NORTH ANNA POWER STATION

UNITS 1 and 2

TECHNICAL SPECIFICATION CHANGE REQUEST

HEATUP/COOLDOWN LIMITATIONS
LOW TEMPERATURE / OVERPRESSURE PROTECTION

Figure 3.4-2 Unit 1 RCS HEATUP P/T Limits
Valid to 12 EFY Heatup Rates: 0-60°F/Hr.
(Margins for Instrument Errors NOT Included)

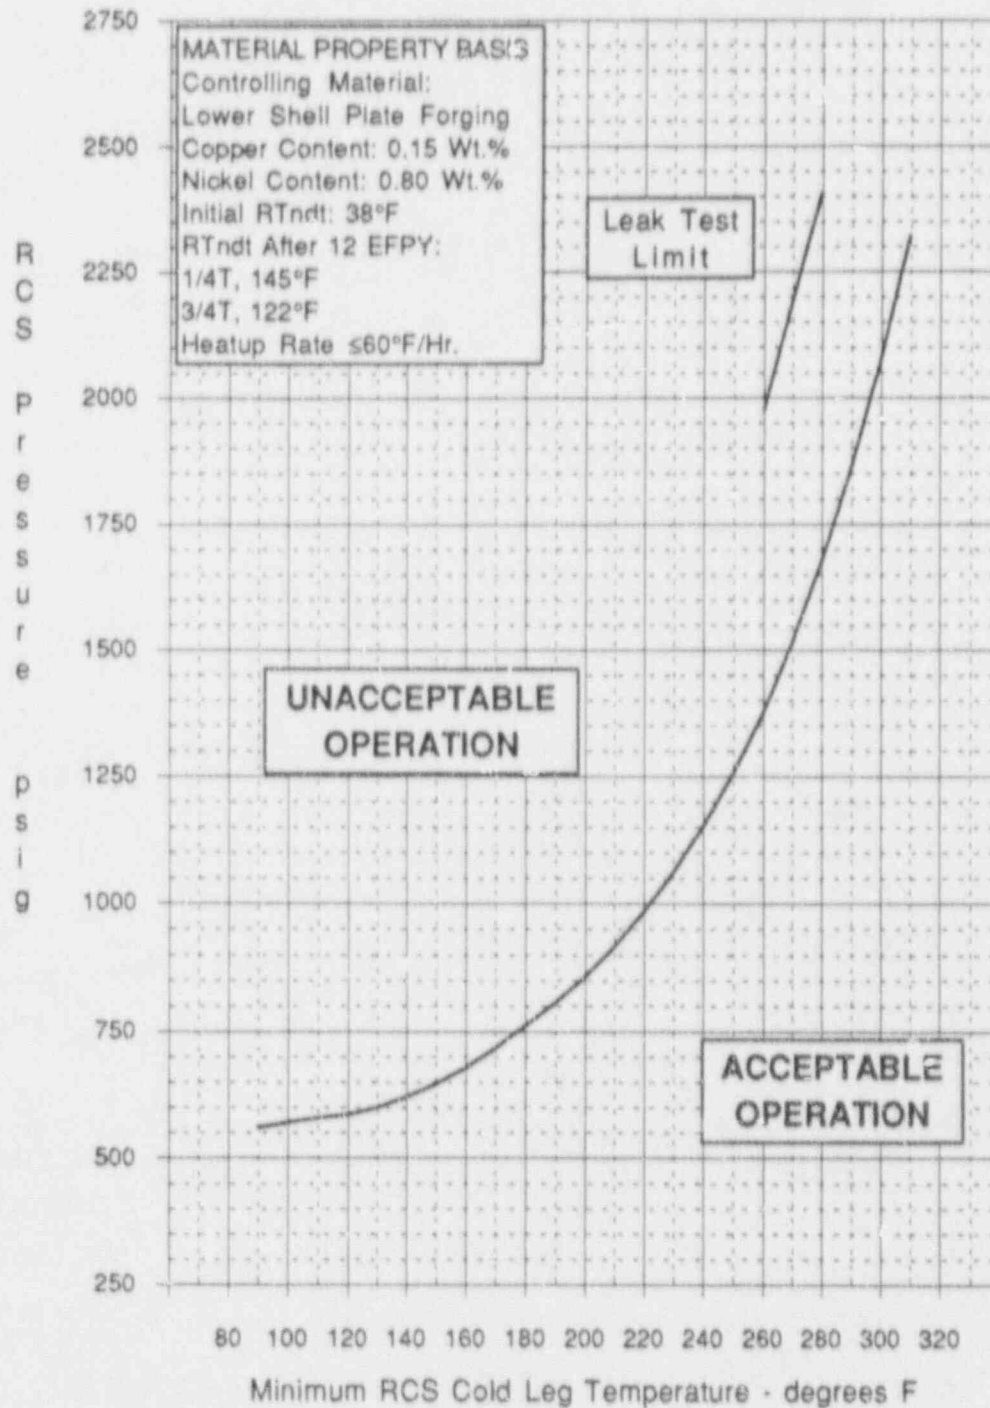
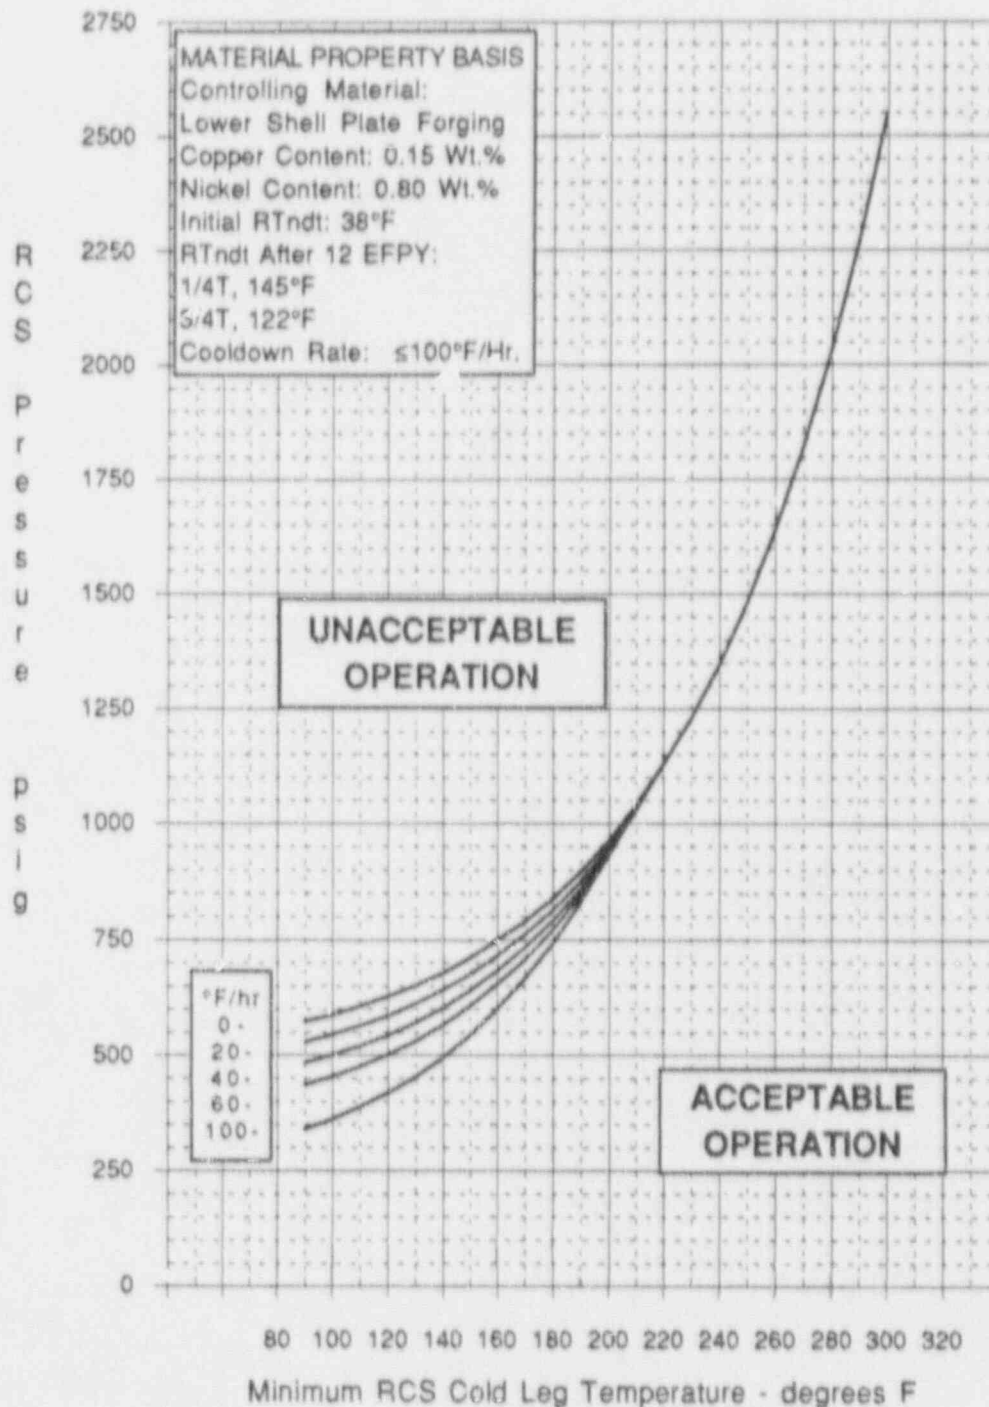
T.S. 3.4.9.1 indicates that T.S. Figures 3.2-2 and 3.4-3 provide pressure and temperature operating limitations at criticality. The criticality limit line has been eliminated from the heatup curve in Figure 3.4-2 in favor of the more restrictive T.S. 3.1.1.5 minimum temperature for criticality. The text of T.S. 3.4.9.1 has been modified to reflect this change.

Technical Specification Figures 3.4-2 and 3.4-3

PRESSURE/TEMPERATURE LIMITS - HEAT UP&COOLDOWN CURVES

Revised T.S. Figures 3.4-2 and 3.4-3 have been prepared presenting the revised Unit 1, 12 EFPY and Unit 2, 17 EFPY heatup and cooldown curves. The revised curves do not include allowances for temperature and measurement uncertainty. The bases have been modified to reflect this change. The development of these curves is discussed in greater detail in a later section. The criticality limit line has been excluded from the heatup curve in Figure 3.4-2 in favor of the more restrictive Technical Specification 3.1.1.5, Minimum Temperature For Criticality. (The Material Property Bases table, presented on these figures, has been added to the Bases.)
